Northern Beaches Tunnel – Application Number: SSI_8862 3

Submission from:

Mark & Carolyn Morrison

Beaches Link Tunnel Project:

Noise and vibration impacts during construction

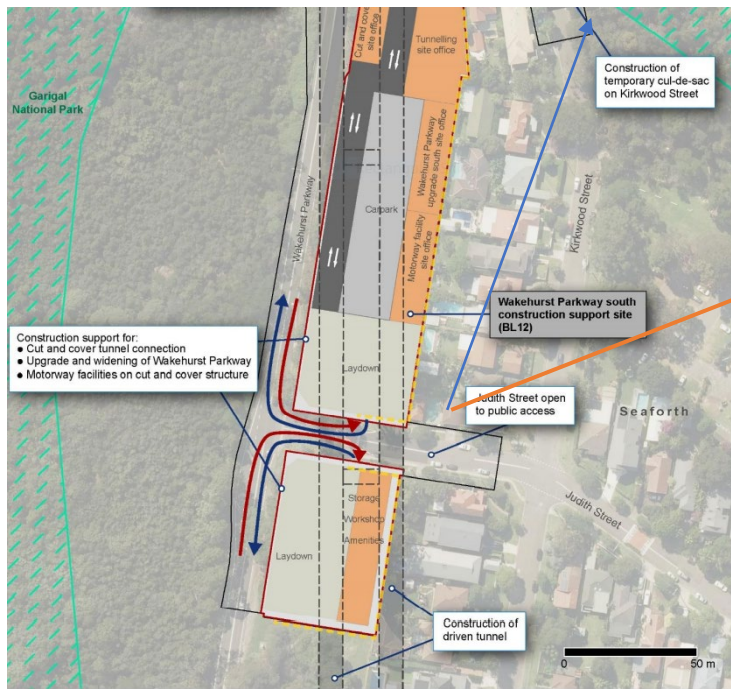
We will have;

- a construction support site/laydown shed directly behind our house with vehicle movements on both sides of our property.*
- a construction site, tunnelling, directly under my house*
- a construction site, cut and cover, to the north west of us*
- a construction site, BL13, to the north & northeast*

Our home impacted on 2 sides/ BL12 – with the BL13 site only 275mtrs to the north/north west of here

10.3.1 Noise sensitive receivers and noise catchment areas

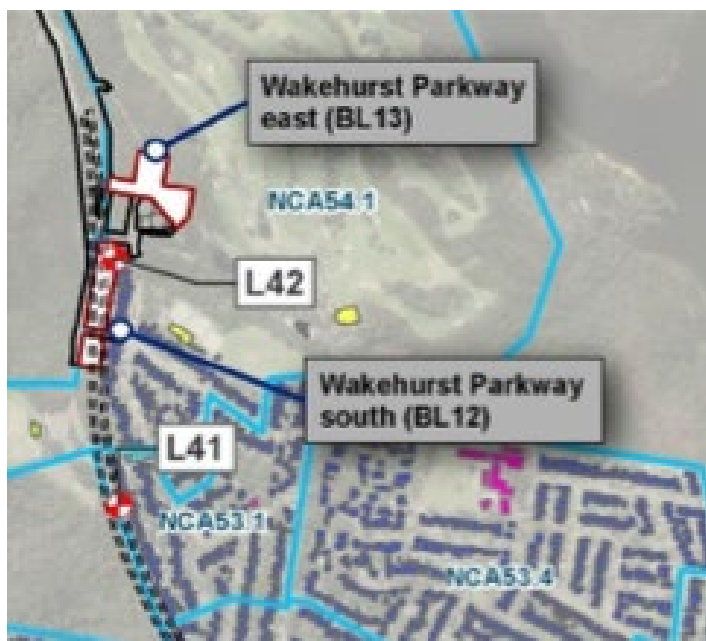
P10-9 Kirkwood is mostly area NCA 54..1. Near by is NCA 53.1&4. What is L42?

P10-13 Is this over the normal day time noise level? Can we get the ambient noise level measured in Kirkwood St?

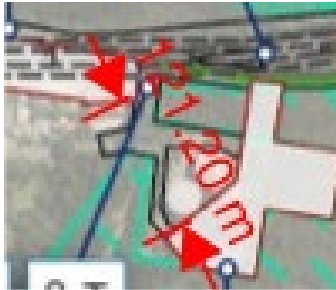
P10-32 We have 6 construction activities in our vicinity

- 1) BL 12 between Kirkwood, Judith and the Wakehurst to the west
- 2) BL 12 south of Judith
- 3) BL 13 spoil removal to the northeast
- 4) cut and cover construction to the north west
- 5) rock hammer, blasting and tunnelling below
- 6) Construction employee movement on Kirkwood St to the east

The cumulative effects of the noise from numerous work sites around us will significantly interrupt our sleep patterns which poses a great risk to our general health and wellbeing.
